# TMC SPECIFICATION

NO. S-1282 *28.4*

INSTALLATION SPECIFICATION

SBG-1 & 2 REPLACEMENT WITH MMXM-2

FIG. 2 MMX SLIDE LOCATION

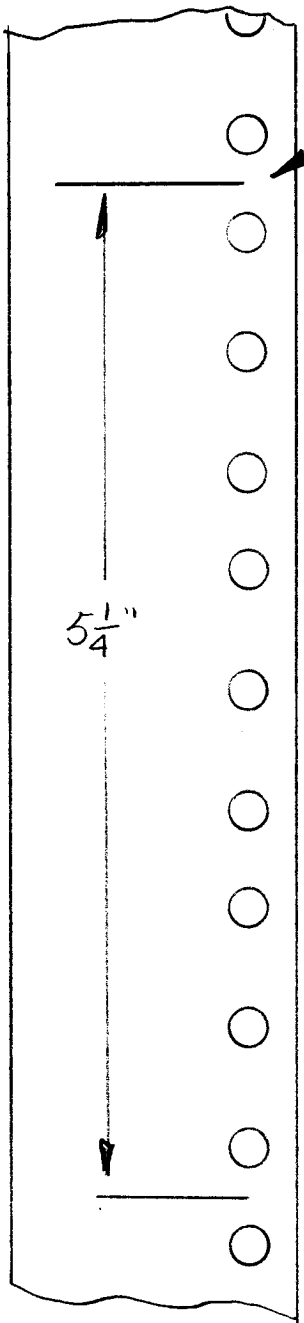
7. Mount the small tilt slide set into the frame located as per figure 2. Mount the tilt portion to the MMX. **CAUTION:** The slide set has a left and right slide. On the frame portion the nameplate must face upright. The unit portion must lock into place in the frame portion.

MARK OF TOP OF CMO

MMX TO BE PLACED IN THIS AREA

CAUTION: SLIDE SET HAS LEFT & RIGHT SIDES

ON FRAME MOUNTED PORTION NAMEPLATE SHOULD FACE RIGHT SIDE UP.

ON UNIT MOUNTED PORTION CHECK FOR PROPER LOCKING OF SPRING LOADED LOCKING MECHANISM.

FIG. 3 CA1635 INST.

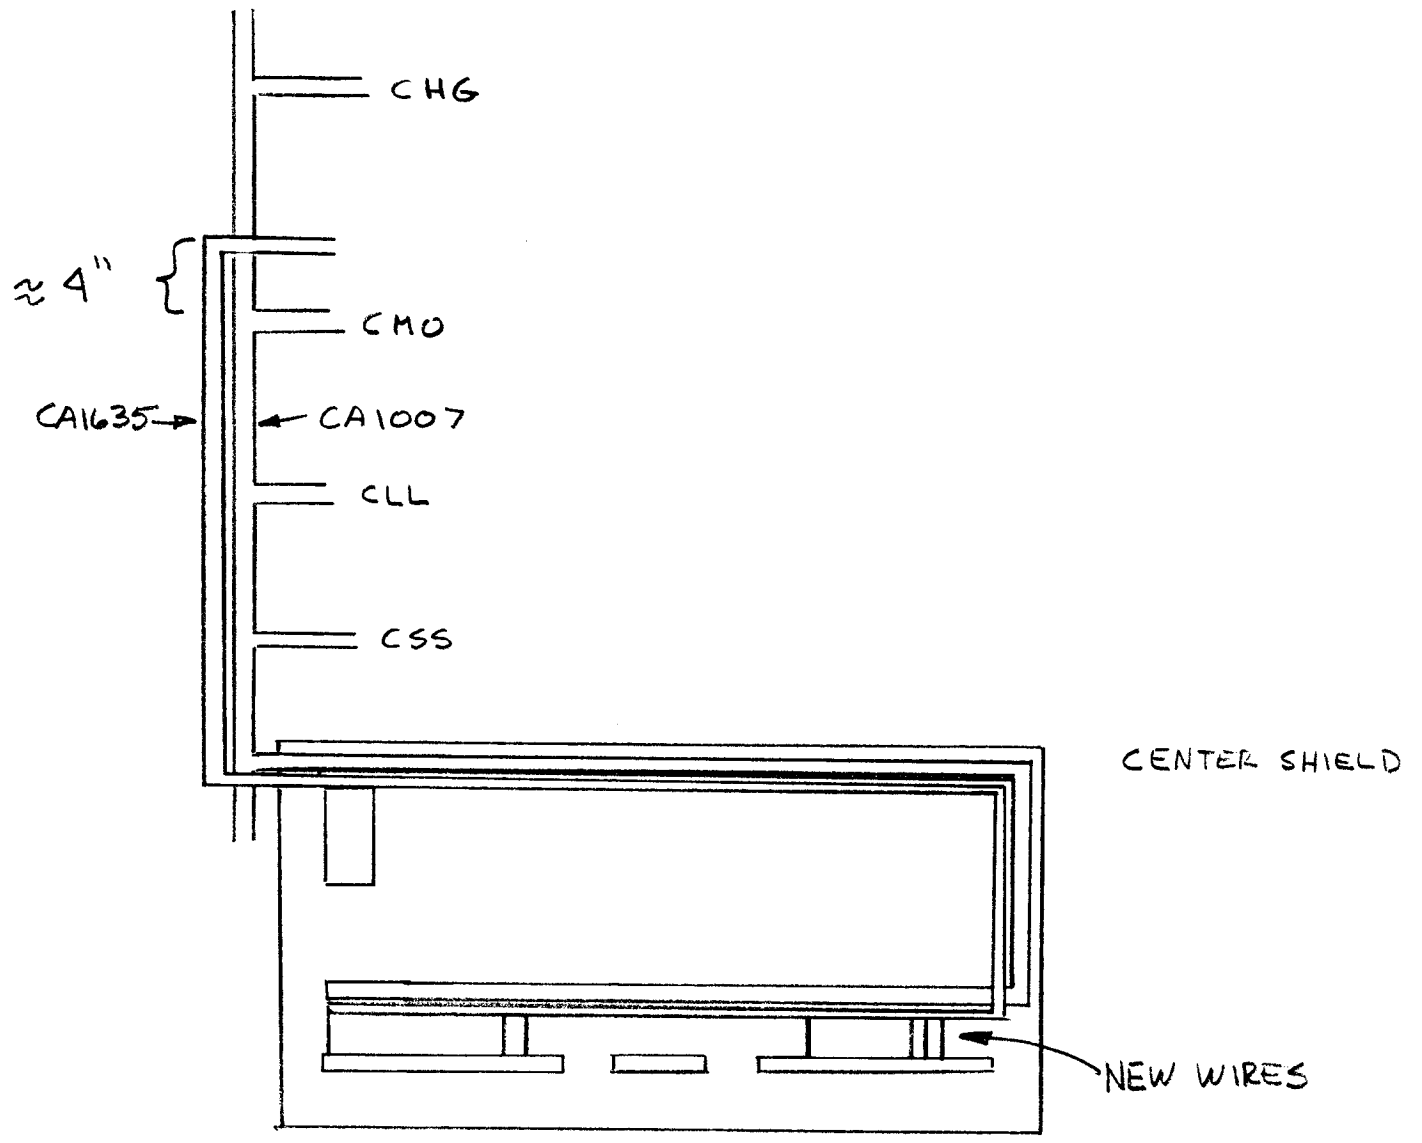
1. Locate the end of CA1635 with the stripped wires.
2. Observe the method of wiring on the center shield.
3. Using the nylon cable straps, clamp CA1635 to the existing harness. Line up the following wires on CA1635 to the proper terminals on the center shield before strapping. See Figure 3.

a) WH1/BRN	E3002	Term 36
b) WH1/RED	E3002	Term 26
c) WH1/BLK	E3002	Term 25
d) GRY	E3000	Term 11
e) ORN	E3000	Term 7
f) RED	E3000	Term 6
g) BRN	E3000	Term 5

Solder the shields to the ground buss.
4. Strap CA1635 along the center shield breakout of the existing harness. The uncovered portion of CA1635 should line up with the main trunk of the existing harness. Line up the uncovered portion along the main trunk upwards and strap. The uncovered portion should end up approximately 4" above the existing CMO breakout.

FIG. 4 CA1007 MOD.

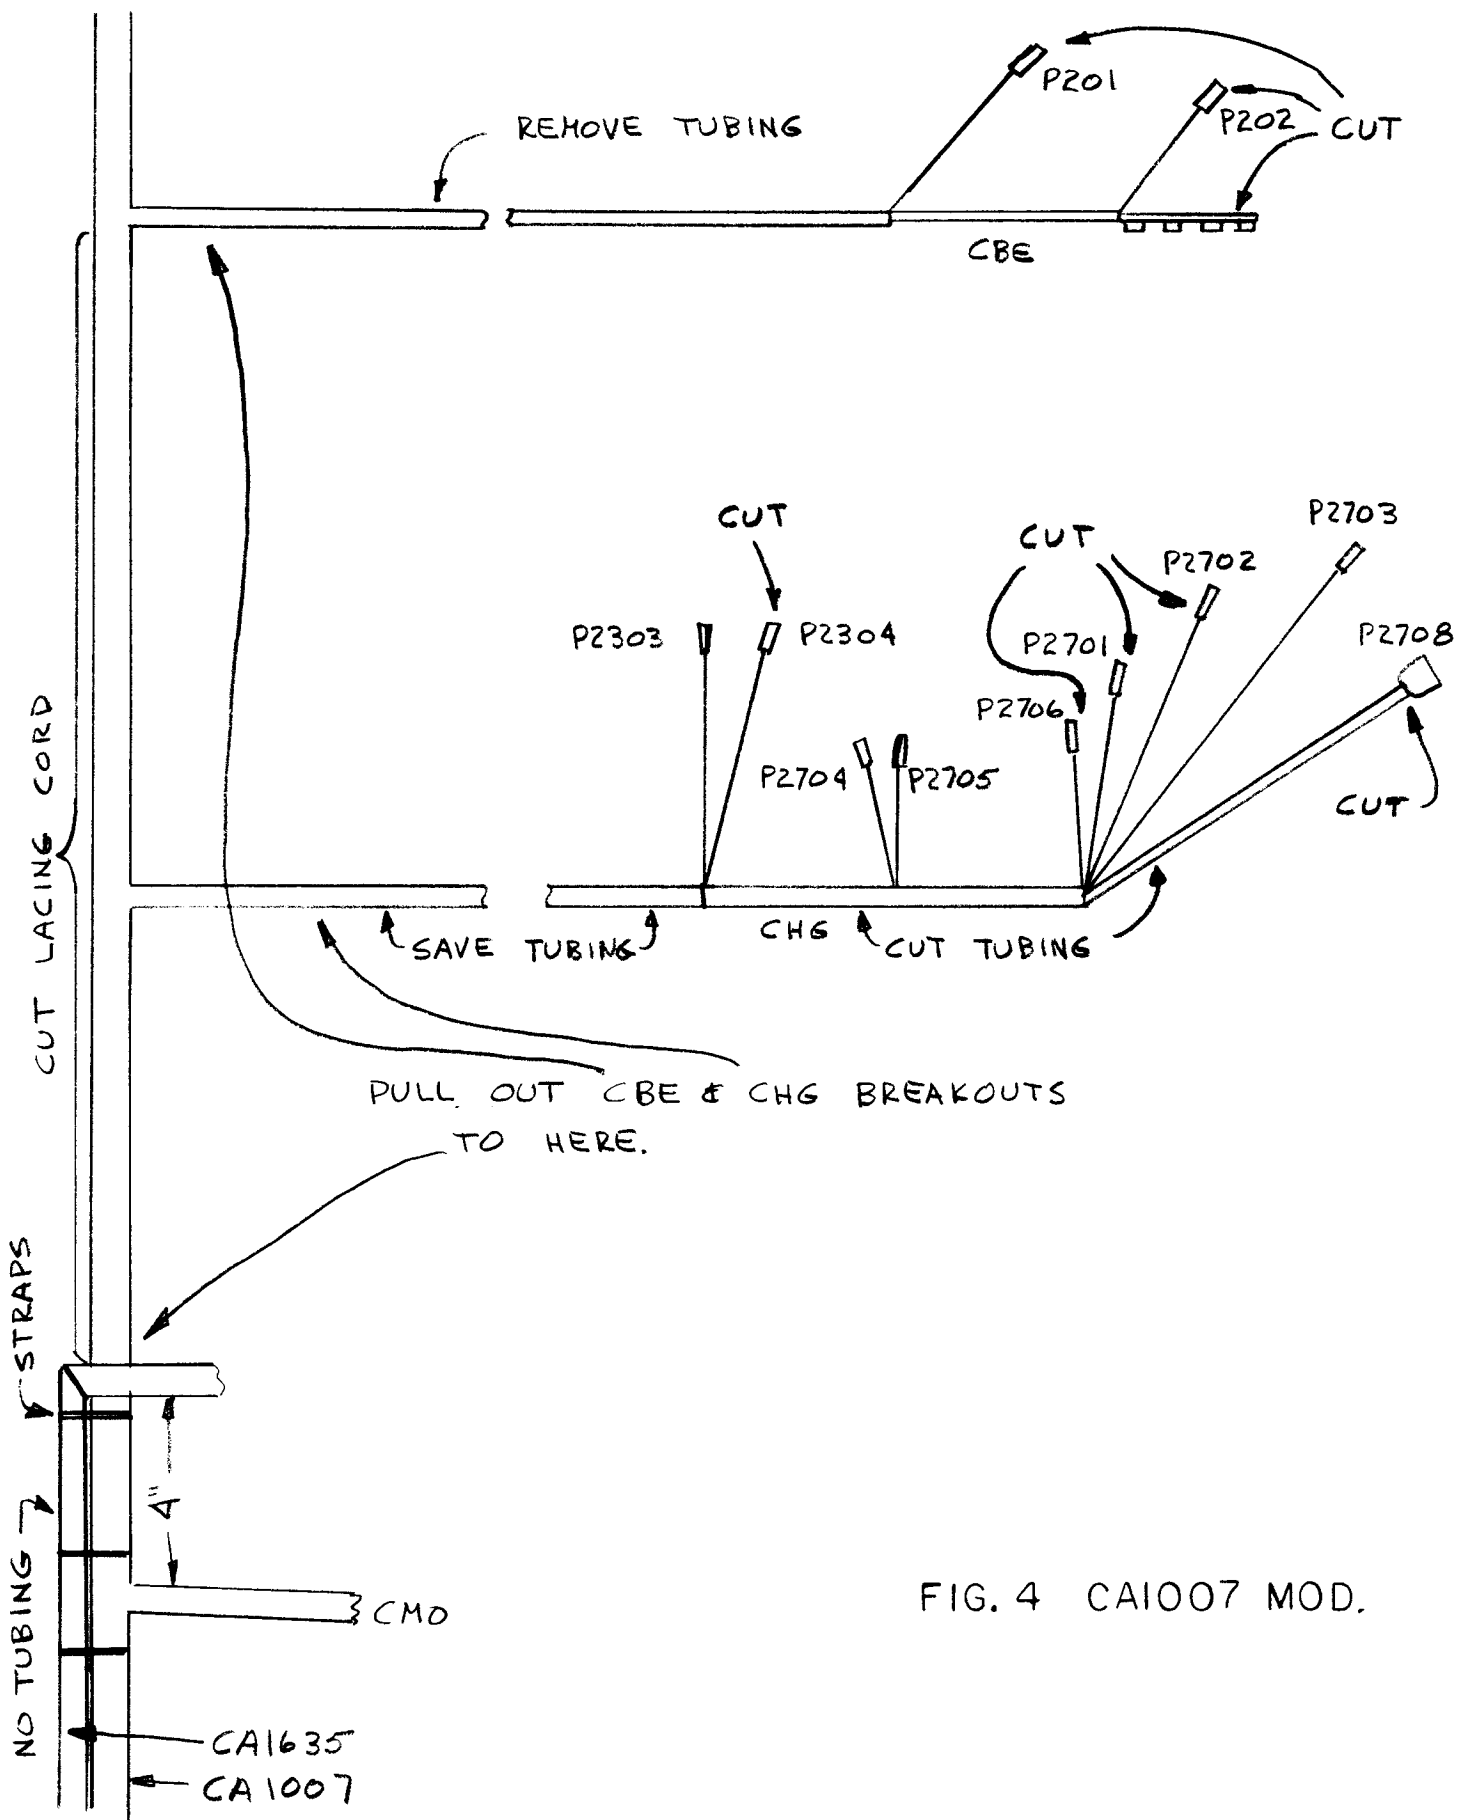
1. Install the BNC feedthru adapter between P3025 and P3026 of the CSS breakout.
2. Cut the lacing cord along the main trunk from the CBE breakout to the point where CA1635 is strapped to the main trunk. (Approximately 4" above the CMO breakout.)
3. Pull the wires in the CBE and CHG breakouts down to this point. Strap the tubing back around the main trunk. See Figure 4.
4. Cut the wires from the CBE terminal strip wasting as little wire as possible. (YEL, ORN, VIO, BLU). Cut the BNC connectors from the coaxial cables. The shielded wires will be used. The coaxial cable will not. Remove the tubing. See Figure 4.
5. On the CHG breakout cut the following plugs.

a) P2304	(1Mc Output)
b) P2701	(250 Kc In)
c) P2702	(CMO)
d) P2706	(250 Kc Out)
e) P2708	(Cut plug only. Wires to be used)

Cut and remove the short pieces of tubing from P2303 and P2304 breakout to the end. See Figure 4.  
Do not cut P2303, P2703, P2704, P2705
6. The wires from the CBE and CHG breakouts should be pulled down the main trunk to the new CA1635 breakout. Slide the long piece of tubing of the CHG breakout down to the main trunk and trim to same length as the new breakout. See Figure 4.
7. Using the unused coaxial cables as pull wires pull the YEL, VIO, ORN and BLU shielded wires from the CBE through the tubing on the old CHG breakout.
8. Pull back to the main trunk all cut coaxial wires.

FIG. 5

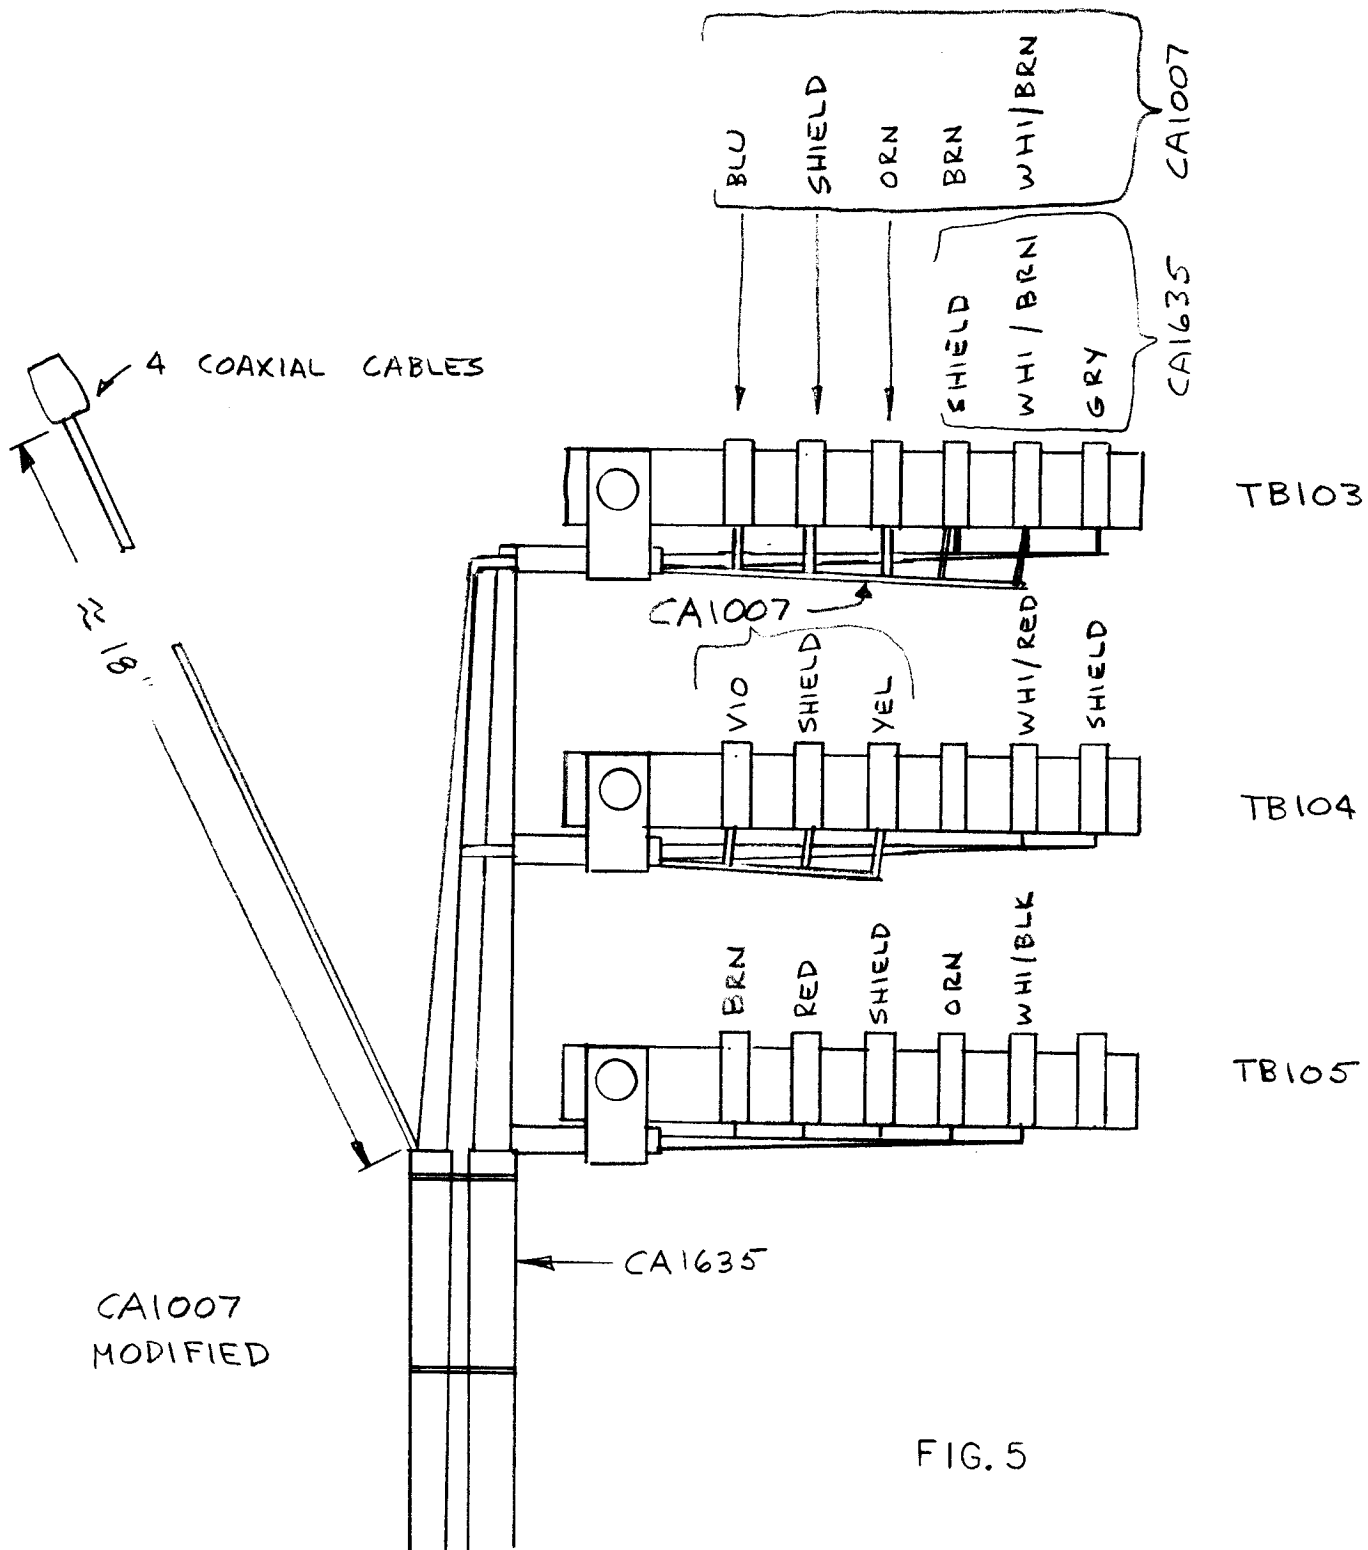
9. Pull the BLU and ORN shielded wires and the BRN and WH1/BRN wires thru the tubing and clamp of TB103 fanning strip. Connect as follows:

BLU to Lug 1  
ORN to Lug 3  
SHIELDS to Lug 2  
BRN to Lug 4 with existing shields  
WH1/BRN to Lug 5 with existing WH1/BRN

10. Pull the VIO and YEL shield wires thru the tubing and clamp of the TB104 fanning strip. Connect as follows:

VIO to Lug 1  
YEL to Lug 3  
SHIELDS to Lug 2

11. At the main trunk pull back the 4 coaxial cables that will be used for the MMX so that they will be approximately 18" long from the junction of the two cables at the fanning strips. See Figure 5.
12. Using the cable straps, dress up the wiring of the rack by tying back all unused branches and the extra lengths of coaxial cable pulled back.
13. Using the labels provided, change the labeling on the coaxial leads as shown in Figure 6.
14. Place the MMX in the rack and replace the TIS in the rack and connect the cabling to the units.
15. Install the blank panels in place.
16. Add the modification nameplate to the equipment.
